20-34

Fan Shroud Interference on FLD Vehicles

Freightliner
Service Bulletin

Fig. 1, Removing the Lower Corners of the Fan Shroud

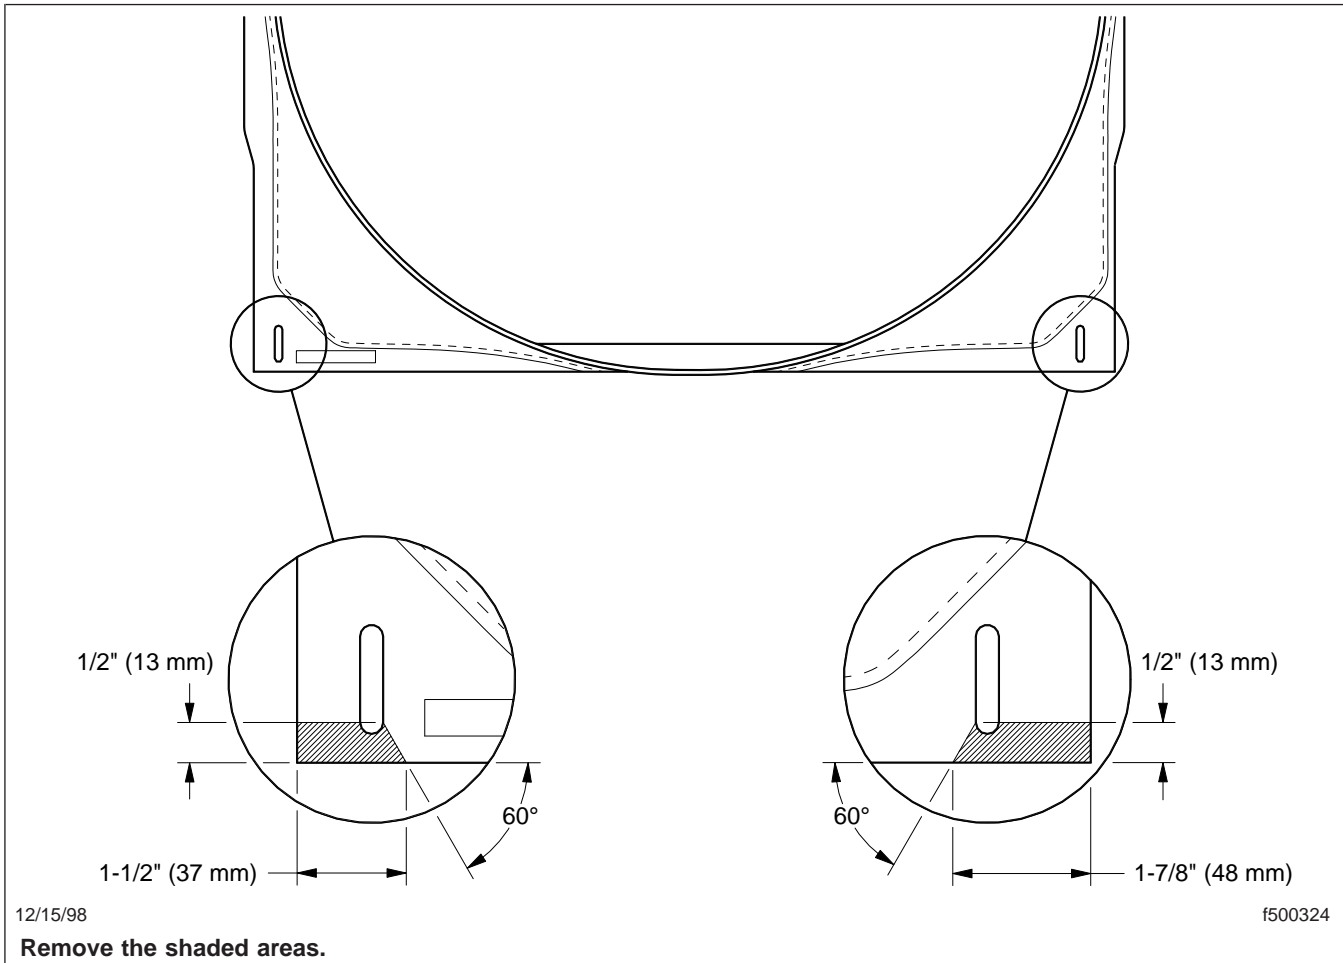
5. If the shroud is contacting the frame-rail extension, go to the step for removing the lower corners of the fan shroud.

6. Remove the lower corners of the fan shroud.
 - 6.1 Remove the four fasteners holding the shroud in place.
 - 6.2 Using either a cutting wheel or a die-grinder, remove the bottom corners of the fan shroud, as shown in [Fig. 1](#).

- 6.3 Install the fan shroud, making sure that there is at least 1/4-inch (6 mm) clearance between the fan blades and the top and bottom of the shroud. Tighten the fasteners firmly.

Fig. 2, Removing the Frame-Rail Corners (left frame rail shown)

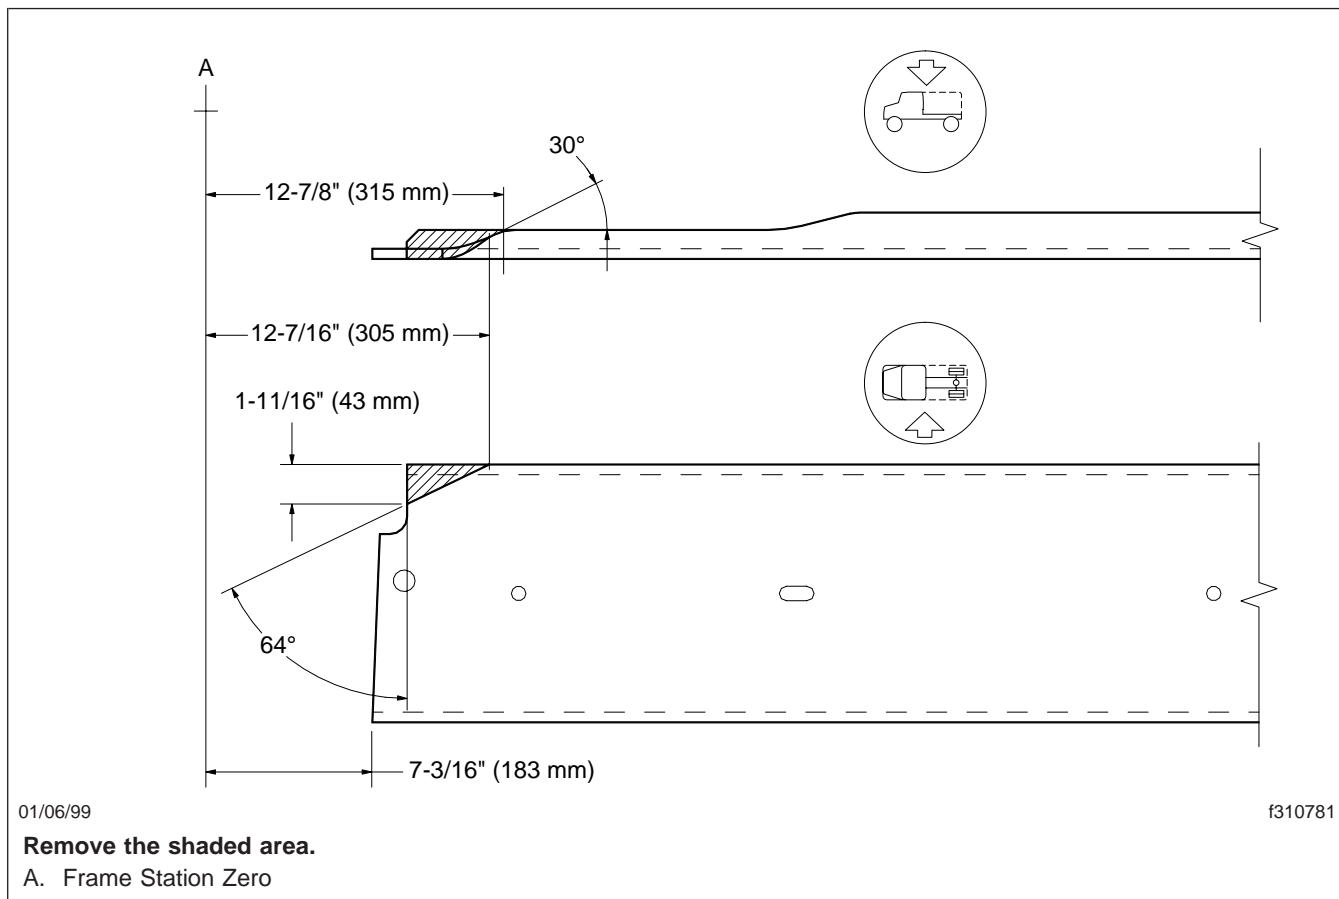
If the shroud is contacting the upper corners of the frame rails, go to the step for removing the upper corners of the frame rails.

- 7.3 Using either a die-grinder or a cutting wheel, remove the upper corner of the frame rail, as shown in [Fig. 2](#).
 - 7.4 Repeat the procedure for the other frame rail.

- 7.5 Install the fan shroud, making sure that there is at least 1/4-inch (6 mm) clearance between the fan blades and the top and bottom of the fan shroud. Tighten the fasteners firmly.
